## Htek IP phones Release Notes of Version

UC926(E)/UC924(E)/UC923/UC921(G)/UC912(E/G)/UC903/UC902(S)

UC9XX--2.0.4.8.12

2021.09.07

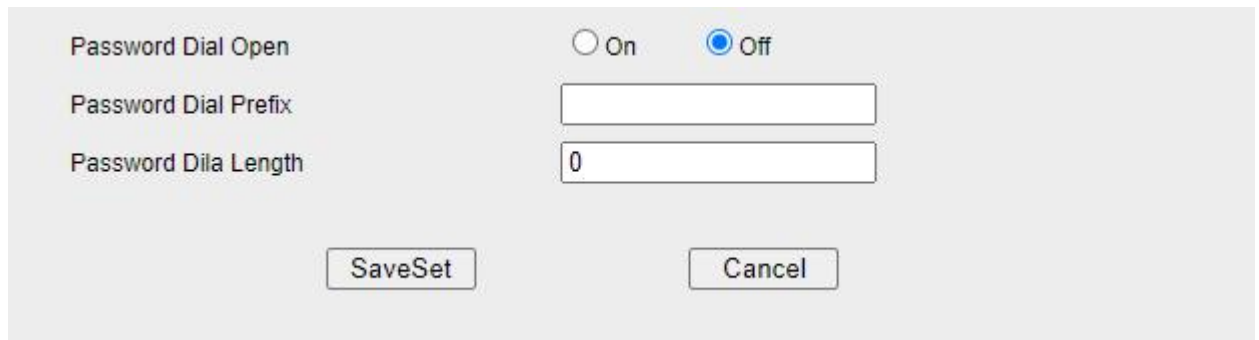
- CDP, LLDP, and DHCP VLAN new mechanisms are incorporated
- Jitter Buffer overflow prevention related changes Check and integration
- Ti3100 synchronous operation of business agreement related changes Check and join
- Add Password Dial

Web -> Setting -> Preference ;p25045:0-off,1-on,default is off
